**Informal document No. GRSG-86-22**  
**(86th GRSG session, 19-23 April 2004**  
**agenda item 3.)**

Proposal to amend document TRANS/WP.29/GRSG/2003/22/Rev.1.

(Transmitted by the expert from OICA)

"Figure 1  
ACCESS TO SERVICE DOORS

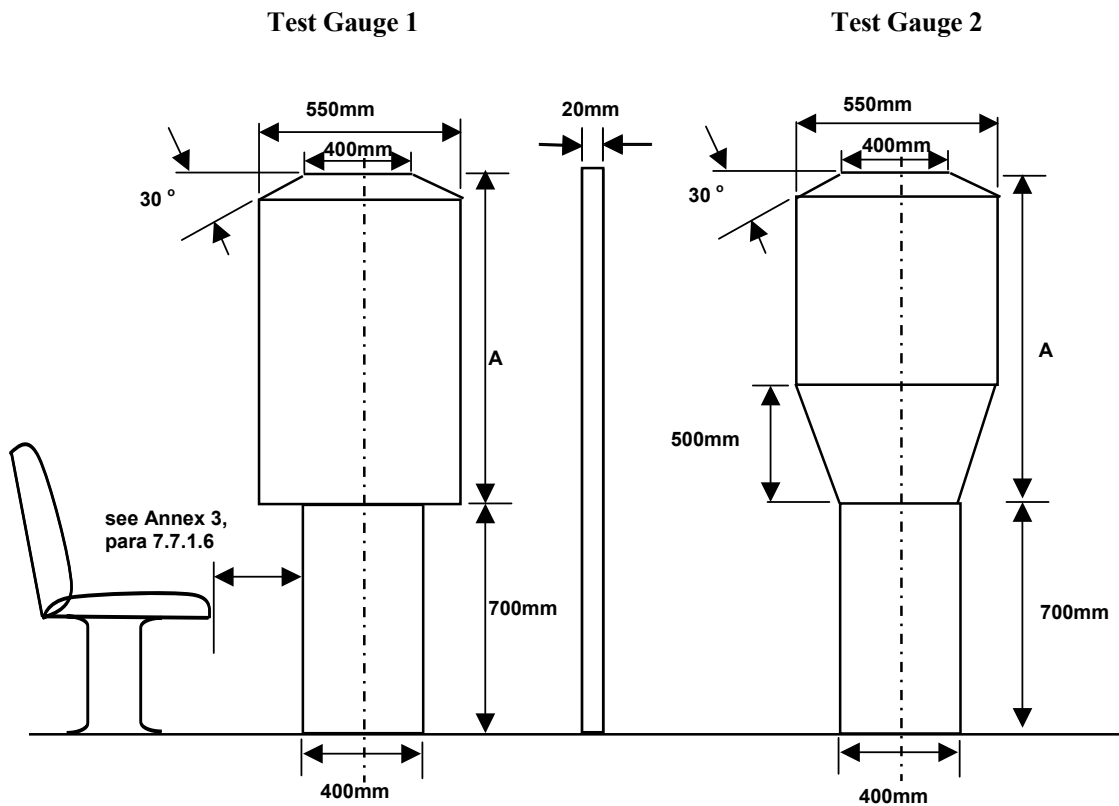
Figure 1, amend to read:

Vehicle Class	Height of the upper panel (mm) (Dimension 'A' figure 1)		Total height
	Test gauge 1	Test gauge 2	
Class A	950 (*)	950	1650
Class B	700 (*)	950	1400
Class I	1100	1100	1800
Class II	950	1100	1650
Class III	850	1100	1550

(\*) For vehicles of Class A or B, the lower panel may be displaced relative to the upper panel provided that it is in the same direction."
